INALWAYS ELECTRONICS INC.

產品變更通知 Product Change Notice

No. 20210309

Inalways P/N(華瑋/力瑋)料號 : 0714-P

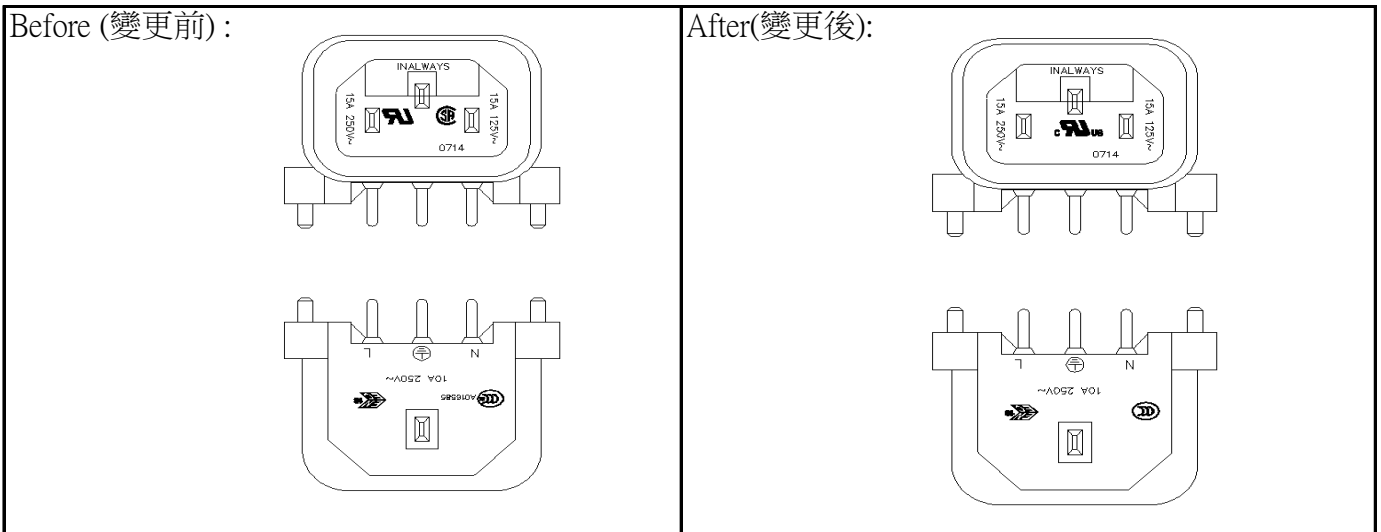
1. 因UL+CSA安規符號整合, UL安規刻字符號變更(UL相同檔案號碼 : E94191)
 In order to intergrate safety marking from UL to CUL, we conduct the marking changes.
2. CCCs --> CCC 因中國政府發佈命令, 模具採自然切換, 於本次其它安規刻字變更一起進行
 According to China governement order of CCCs --> CCC marking, we conduct CCC changing as well
3. 變更後的圖紙如附件
 The drawings are as attached files.
4. 變更刻字後的出貨將於 2021/6/1 開始不晚於 2021/6/30
 The marking changes shipment will be started from 2021/6/1 and no later than 2021/6/30
5. 本變更只有刻字, 未有材質, 設計, 機台及產地變更.
 This PCN is only for marking, there's no changes for material, design, machine and factory.
